Inspection of main landing gear assembly

All SHARK types and models

This revision supersedes the previous revision of SHARK_SB_010.

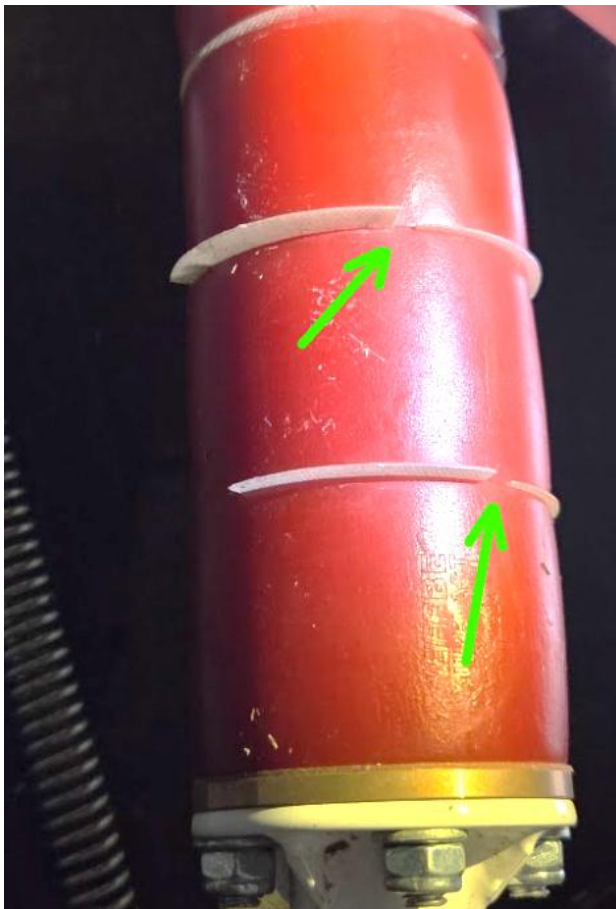
1. Caliper bolts: On some production batches of SHARK aircraft, Nord-Lock washers in combination with Loctite were used to secure the three bolts attaching the brake caliper to the landing gear leg. It was found that this method of securing may not be sufficient. Possible loosening of the bolts can be monitored by visual inspection of the red torque marking applied on the bolt heads. Excessively loose bolts may come into contact with the wheel disc and cause damage to the disc.

WRONG

CORRECT

- Remove existing bolts.
- Replace with bolts mutually safety-wired using locking wire.
- Replacement bolts will be supplied by SHARK.AERO on request.

Brake: 6 pcs bolts - DIN 912 **M6x35, Steel Zinc plated with thick Cr(III+) passivation, Class 8.8**
(supplier for example FABORY, Article number **07067.060.035**)
Shorten bolts from 35 mm to 20 mm
Drill a 1.2–1.6 mm diameter hole through the bolt head, centred at mid-height of the head,
for safety wire installation.
6 pcs washers – DIN 125, M6, Stainless steel

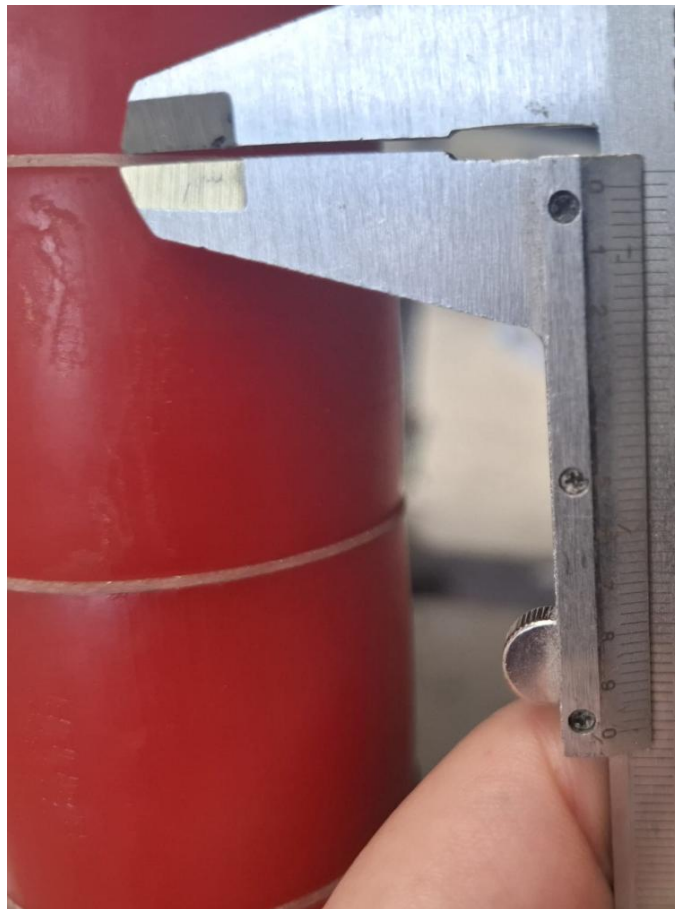
2. Friction washers: Some shock absorbers are equipped with friction washers made of insufficiently thin material. This condition may lead to cracking of the washers and their displacement out of the damper contour.

WRONG

CORRECT

If any washer is cracked or the measured thickness is less than 0.6 mm:

- Remove the shock absorber.
- Replace all friction washers.
- Replacement washers and detailed replacement instructions will be supplied by SHARK.AERO on request.

Shock absorber: 2 sets of washers S6-03-653
